UNITED STATES PATENT AND TRADEMARK OFFICE

10/580,826

Yoshihisa Doi

Office Action Summary	Application No. 10/580,826	Applicant(s) DOI ET AL.	
	Examiner STEPHANIE JENNINGS	Art Unit 4135

FIG. 1

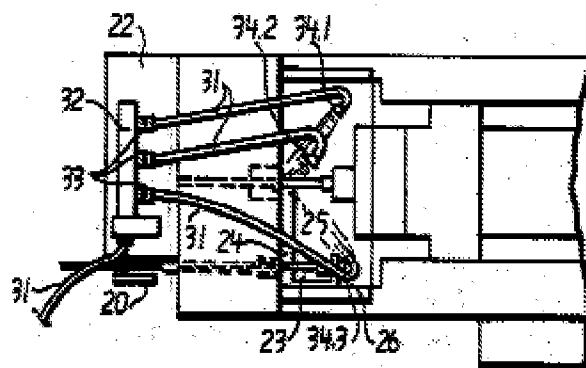
Limitations from claim 7, a forging apparatus (figure 1) comprising an extruding apparatus (7, 10), wherein a workpiece (1) is successively transferred to a series of press stages (figure 1); a conveying unit (figure 1) for successively transferring the workpiece (1) is provided with a nozzle for spraying the workpiece with lubricant (34.1-34.3, figure 3); and the workpiece and the nozzle are located in fixed relative positions to each other in spraying the workpiece (1) with the lubricant (9) (figure 3). Multiple nozzles in a forging press are inherently located relative to each other and therefore cannot be claimed.

FIG. 3

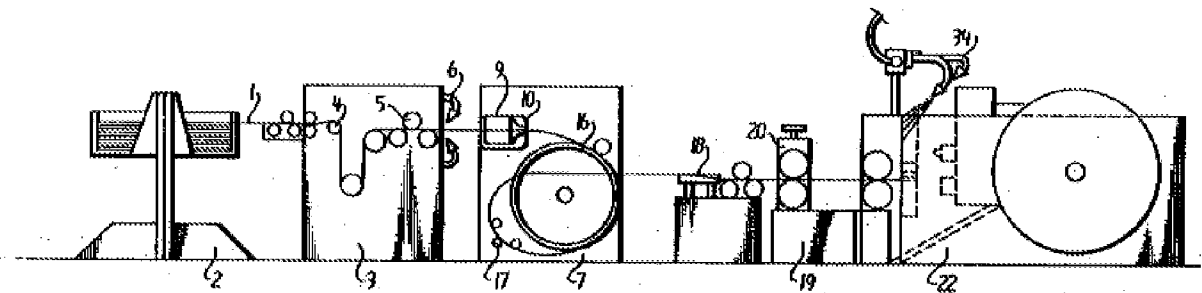
Limitations from claim 1, a forging method including a plurality of press steps for a formed product, wherein a workpiece (1) heated due to the machining in an earlier press step(s) prior to a press step of forming the workpiece (1) undergoes spraying (34.1, 34.2, 34.3) with lubricant (9) more than once (figure 3 above, column 6, lines 16-38); the spraying with lubricant (9) is conducted when the lubricant sprayed in a preceding spraying has been dried (column 6, lines 16-38); and eventually after the lubricant sprayed in the final spraying has been dried, the

Limitations from claim 9, a forging apparatus as defined in claim 7, wherein there are more than one of the nozzles (34.1, 34.2, 34.3) from which the lubricant (9) is sprayed in different directions, and the nozzles spray the lubricant in a sequential fashion (figure 3 and column 7, line 63-column 8, line 3).

Limitations from claim 10, a forging apparatus as defined in claim 9, wherein after the lubricant sprayed from the nozzles has been dried, the lubricant is sprayed from the nozzles (figure 3 and column 7, line 63-column 8, line 3). A drying step is inherent in the process as the

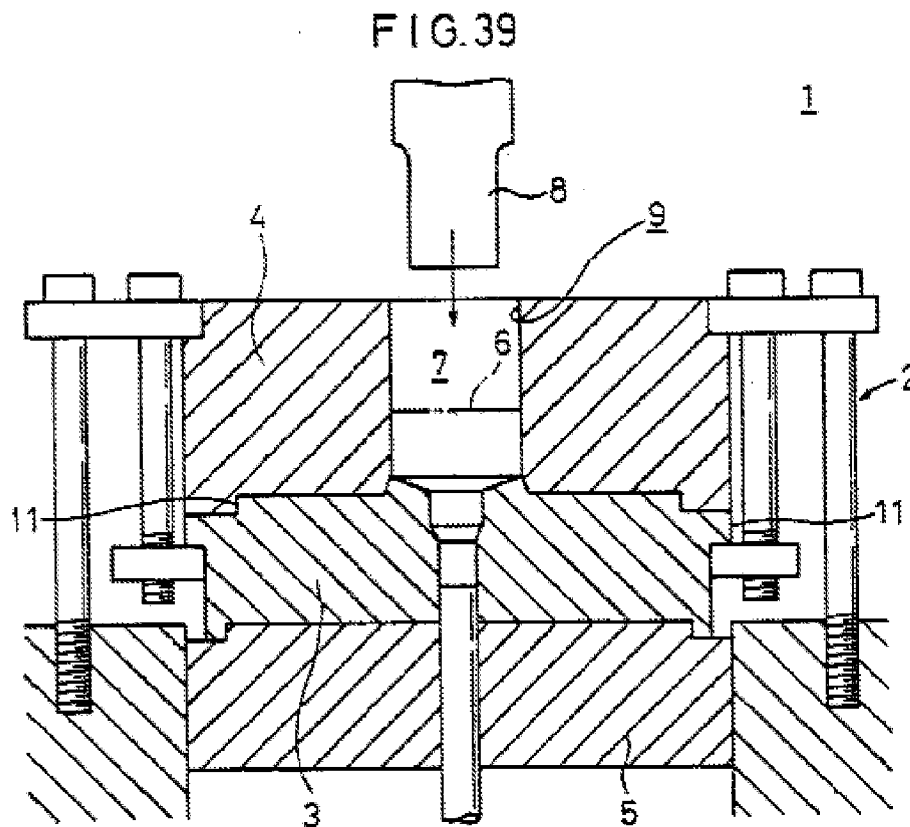
Limitations from claim 5, a forging method as defined in claim 1, wherein the formed product is cup-shaped (8, figure 39 above) (page 1, paragraph 11 and page 2, paragraph 20).

Limitations from claim 6, a forging method as defined in claim 1, wherein the formed product is shaft-shaped (8, figure 39 above) (page 1, paragraph 11).

Limitations from claim 14, a forging apparatus as defined in claim 7, wherein the formed product is cup-shaped (8, figure 39 above) (page 1, paragraph 11 and page 2, paragraph 20).

Limitations from claim 15, a forging apparatus as defined in claim 7, wherein the formed product is shaft-shaped (8, figure 39 above) (page 1, paragraph 11).

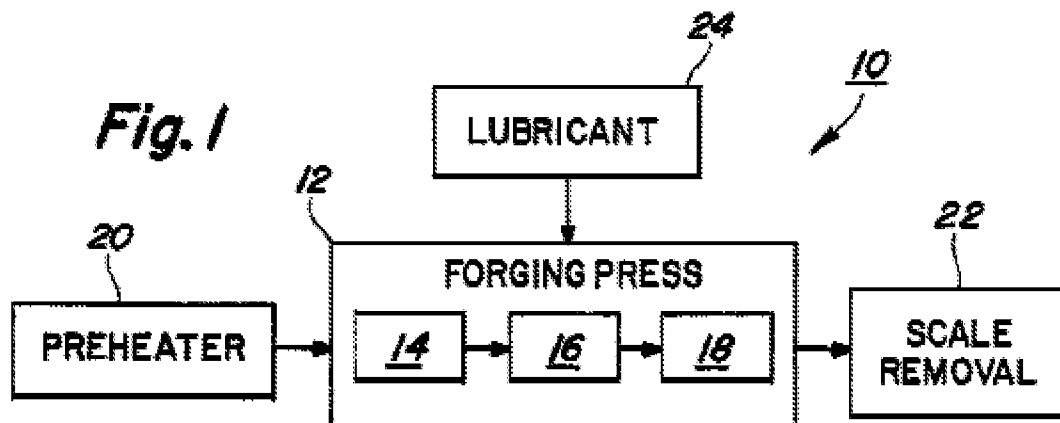
Limitations from claim 4, A forging method as defined in claim 1, wherein the lubricant (24, figure 1 above) before a forging procedure (12) is a water-dispersive lubricant containing a solid lubricant agent, a lubricative and dispersive adherent agent and a wetting and vaporizing accelerating agent, and the lubricant (24) during the forging procedure is a solid lubricant agent (column 3, lines 53-column 4, line 5 and column 4, lines 20-31).

Limitations from claim 13, A forging apparatus as defined in claim 7, wherein the lubricant (24) before a forging procedure (12) is a water-dispersive lubricant containing a solid lubricant agent, a lubricative and dispersive adherent agent, and a wetting and vaporizing accelerating agent, and the lubricant (24) during the forging procedure is a solid lubricant agent ((column 3, lines 53-column 4, line 5 and column 4, lines 20-31).
